2 **BIGAN DAM**

NDI ID NO. PA-237  
DER ID NO. 56-94

3 PHASE I INSPECTION REPORT  
1 NATIONAL DAM INSPECTION PROGRAM

Prepared By  
L. ROBERT KIMBALL & ASSOCIATES  
CONSULTING ENGINEERS & ARCHITECTS  
EBENSBURG, PENNSYLVANIA  
15931

BIGAN DAM  
PHOTO INDEX

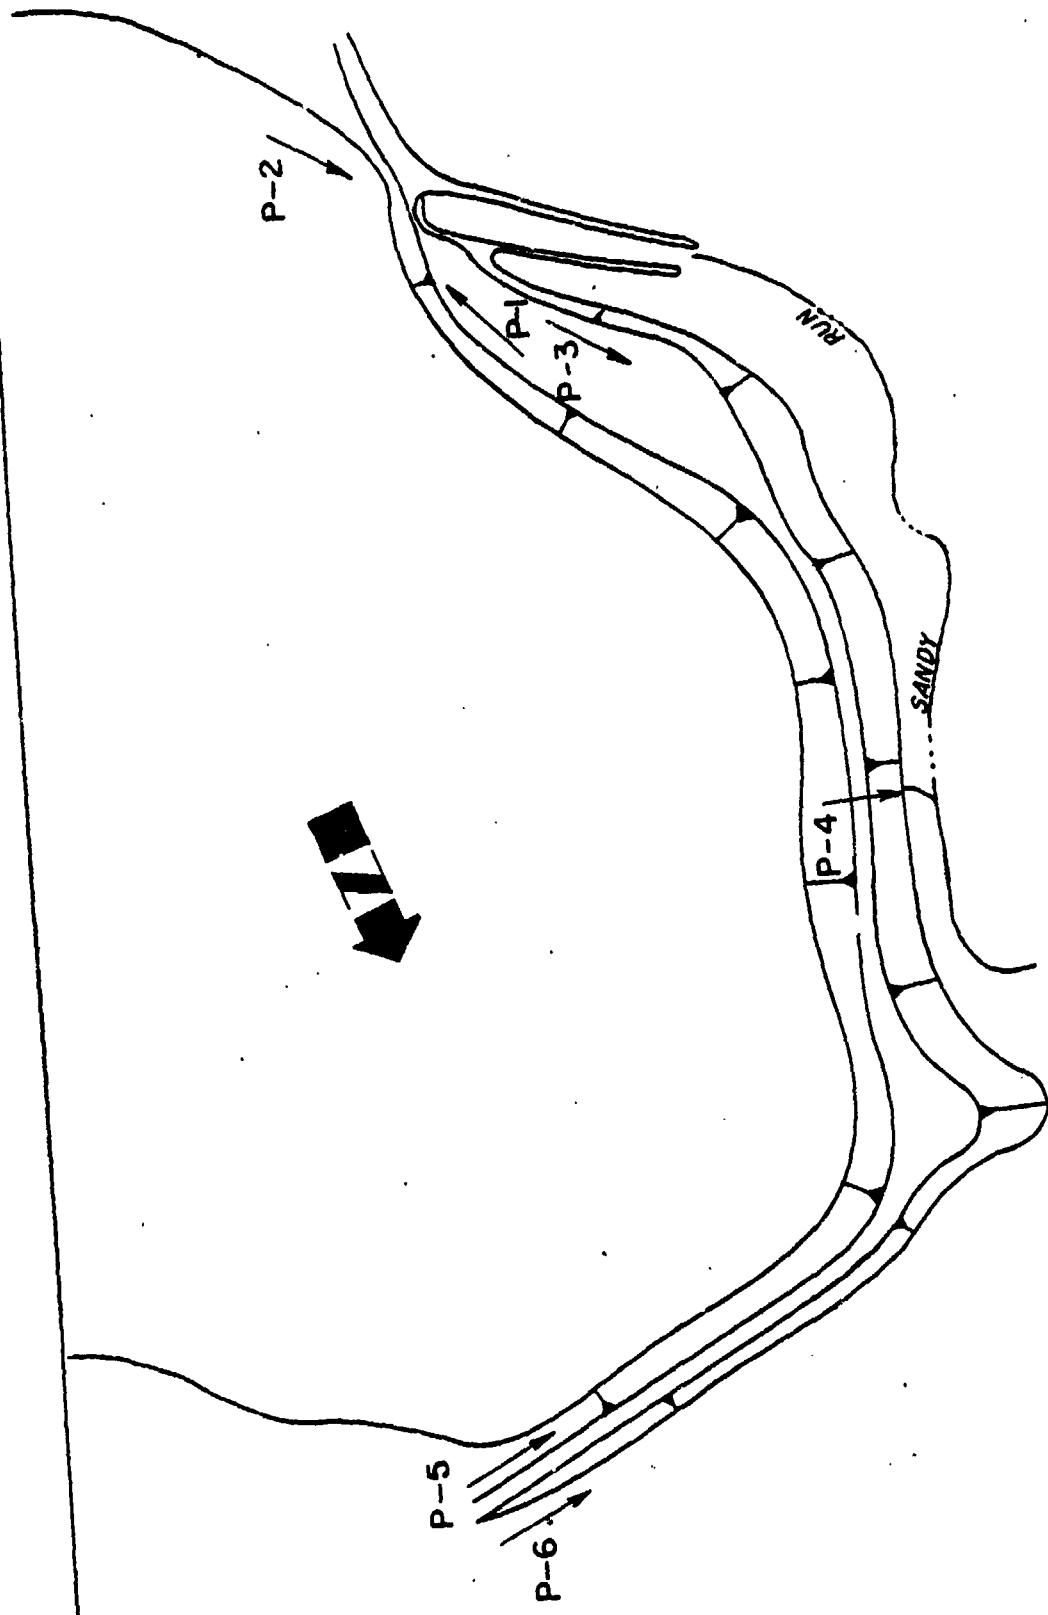
- (1) Upper left - View of spillway approach. View towards the left abutment.
- (2) Upper right - Close-up view of spillway approach and earthen berm across the approach to spillway. Note three corrugated metal pipes through the earthen berm.
- (3) Lower left - View of across the crest of the dam. View towards the northwest.
- (4) Lower right - Outlet for drainline. Note valve at outlet.

- (5) Upper left - View of tension crack along upstream edge of crest. View towards the west.
- (6) Upper right - View along the downstream slope of the northern embankment. View towards the west.
- (7) Lower left - Downstream exposure.
- (8) Lower right - Downstream exposure.
